## TECHNICAL EVALUATION REPORT

EVALUATION OF SPENT FUEL RACKS STRUCTURAL ANALYSIS  
FLORIDA POWER AND LIGHT COMPANY  
ST. LUCIE GENERATING STATION UNIT 2

NRC DOCKET NO: 50-389

September 19, 1984

Figure 4. Maximum Stress Location in the Module

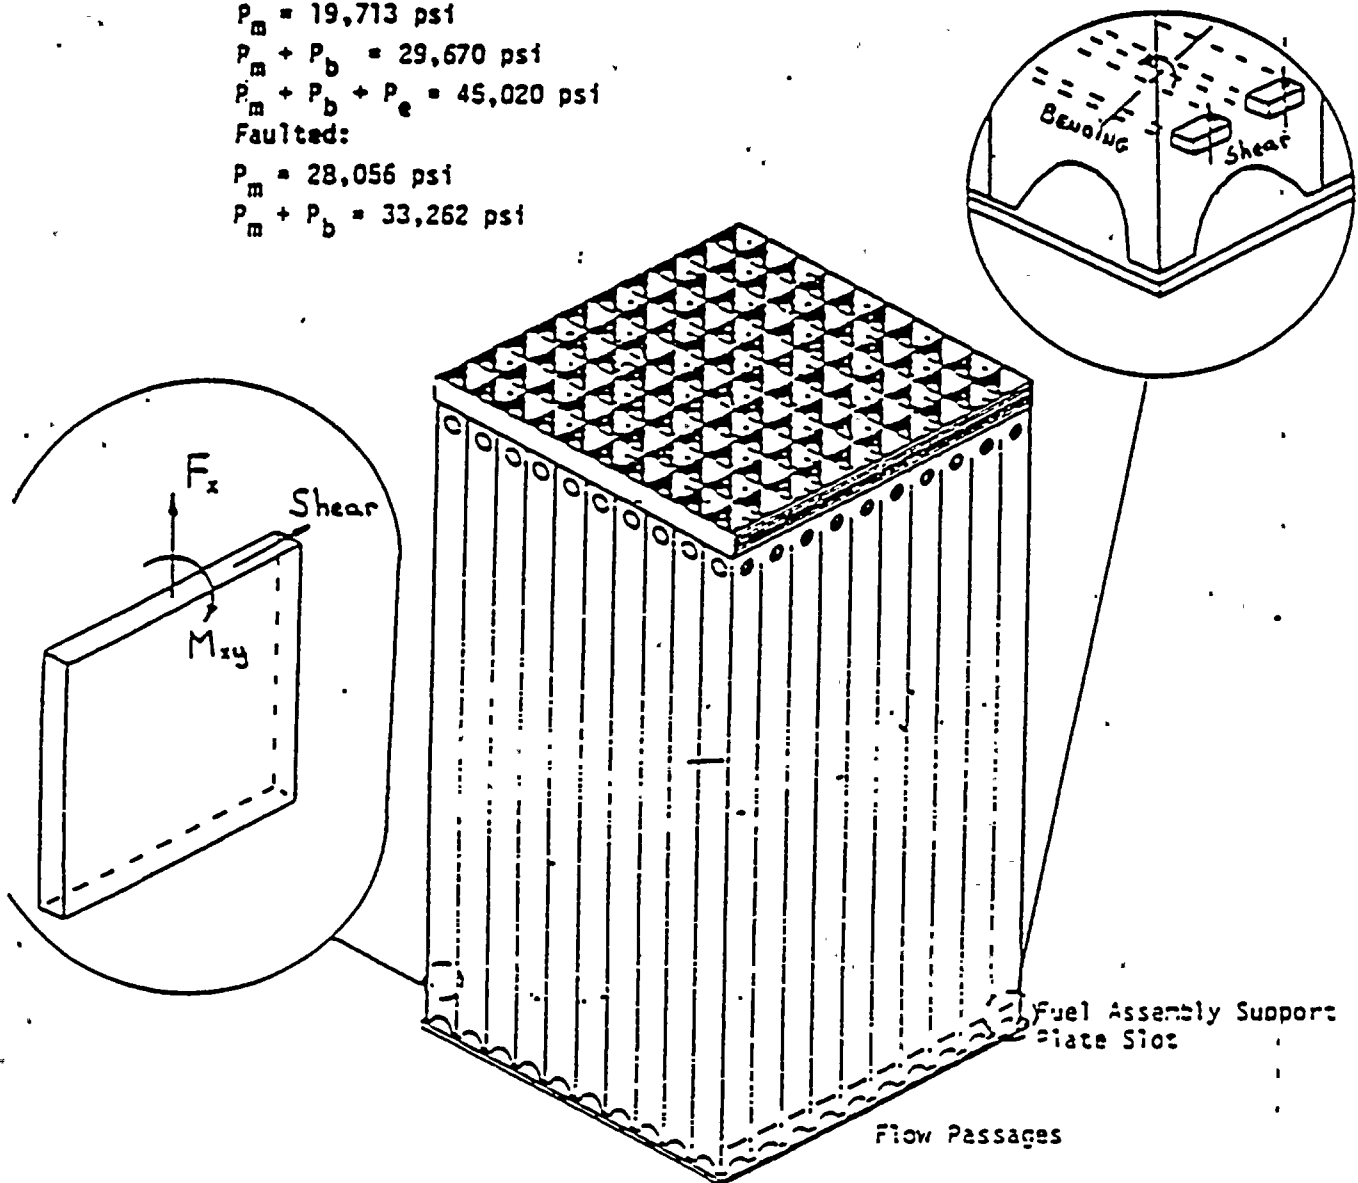
The maximum stresses were found at the plate elements of the fuel cell wall at an elevation near the fuel lower end fitting and support bar interface [5]. The maximum stress points were clustered near the module/liner support points (see Figure 4).

The margin of safety for the worst case is as low as 1.1%. The Licensee stated that the analysis results are acceptable because of the conservative assumptions made in the analysis (see Subsection 3.3.2).

Although the analysis method is not satisfactory for general application where liftoff does occur because of the omission of a moment load factor applied to the stress model from the non-liner model, the review and evaluation indicated that the stress analysis is acceptable because liftoff does not occur in these cases.
